**IMPERIAL METALS CORPORATION  
MT. POLLEY PROJECT**

**RESPONSE TO REVIEW COMMENTS  
ON TAILINGS EMBANKMENT DESIGN  
(REF. NO. 1625/6)**

**JANUARY 25, 1996**

DRG. NO. 510-77-01-1625.220

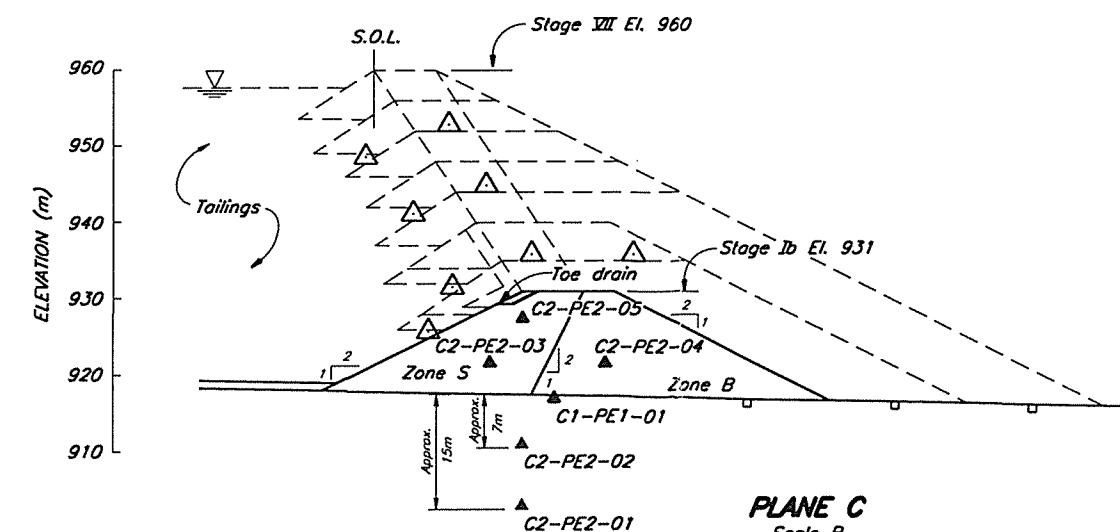
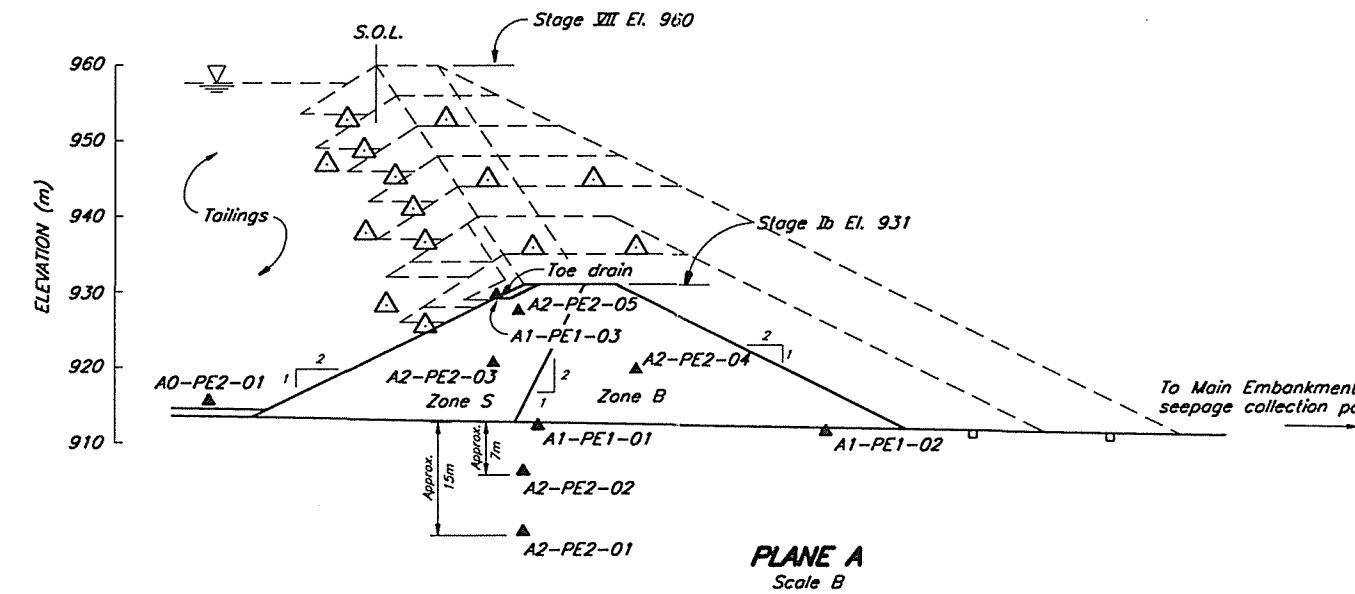
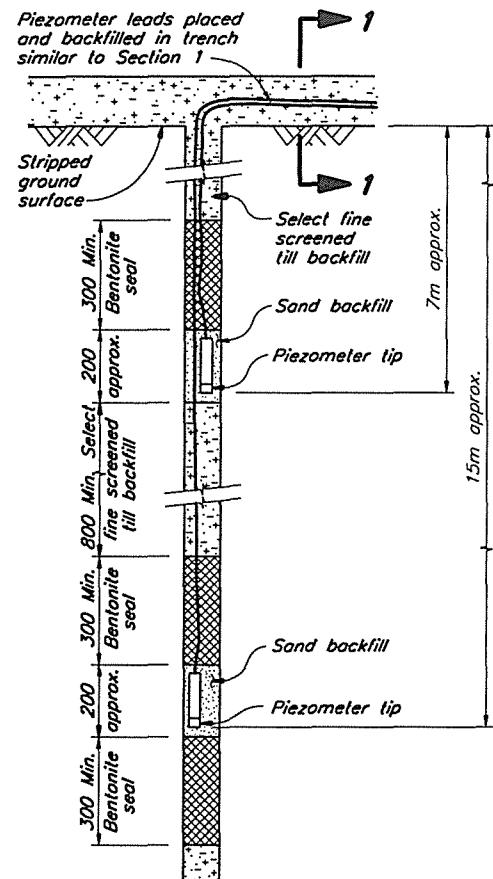
*Only one drill hole appears to have been drilled in the main embankment area. In B.C. valleys there is always the possibility of buried high permeability zones. It is recommended that 2 more boreholes to expand the geotechnical information be drilled and tested.*

One hole has been drilled in the Main Embankment area (MP89-234), as noted by Mr. Brawner. It has previously been discussed with Mr. Headley (MEMPR) and it was agreed that three additional holes will be drilled, logged and sampled by a geotechnical engineer during the initial stages of construction as part of the embankment instrumentation and monitoring requirements. The holes are specified in

the Technical Specifications and shown on Drawing Nos. 510-77-01-1625.220 and 1625.221. They will be drilled to about 15m depth and will be located in the bottom of the main valley, where significant overburden is known to be present. Lab testing will be conducted on the samples as required and vibrating wire piezometers will be installed in the embankment foundation for long term water pressure monitoring.
